**REQUEST**

Current Zoning: R-22MF(CD) (multi-family residential)  
Proposed Zoning: UR-2(CD) (urban residential, conditional)

Approximately 10.81 acres located in the western quadrant of the intersection of North Poplar Street and West 28th Street, south of Atando Avenue.

**SUMMARY OF PETITION**

### • **Proposed Request Details**

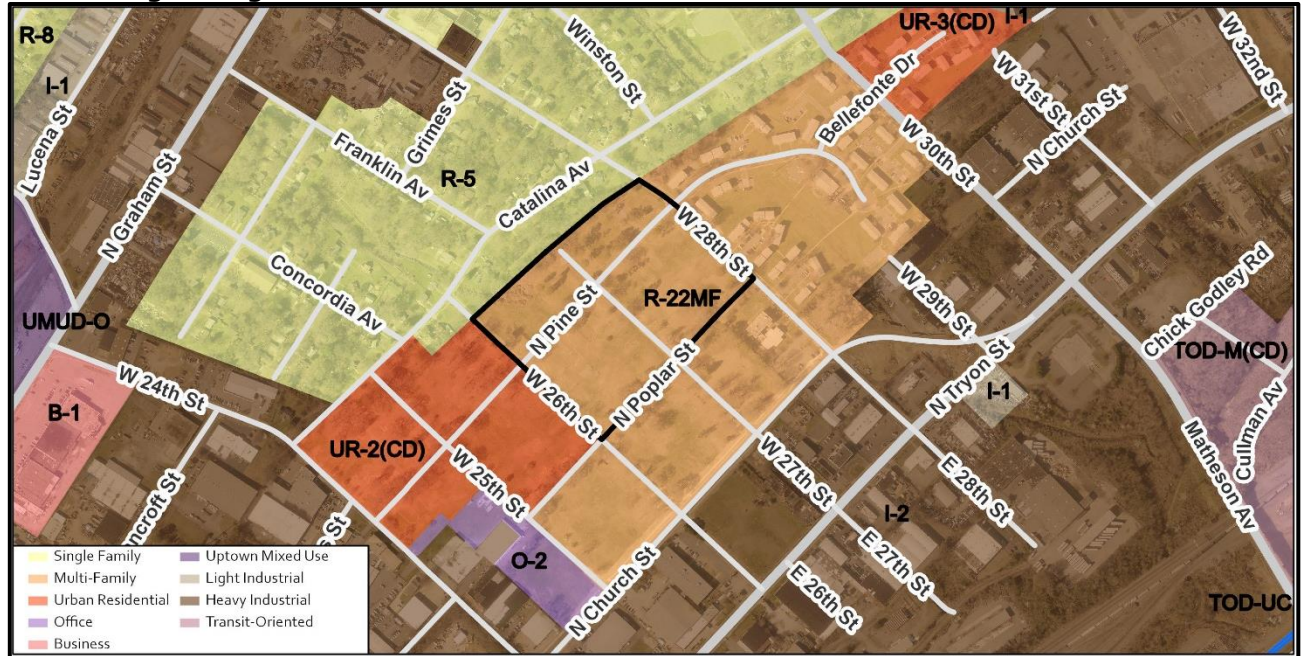
- Commits to installing an 8-foot planting strip and 8-foot sidewalk along street frontages.
- Utilizes existing road network to preserve connectivity.
- Commits to a ~~three~~ **Four-foot** high masonry wall to screen surface parking areas over 100-feet in length fronting an existing public street.
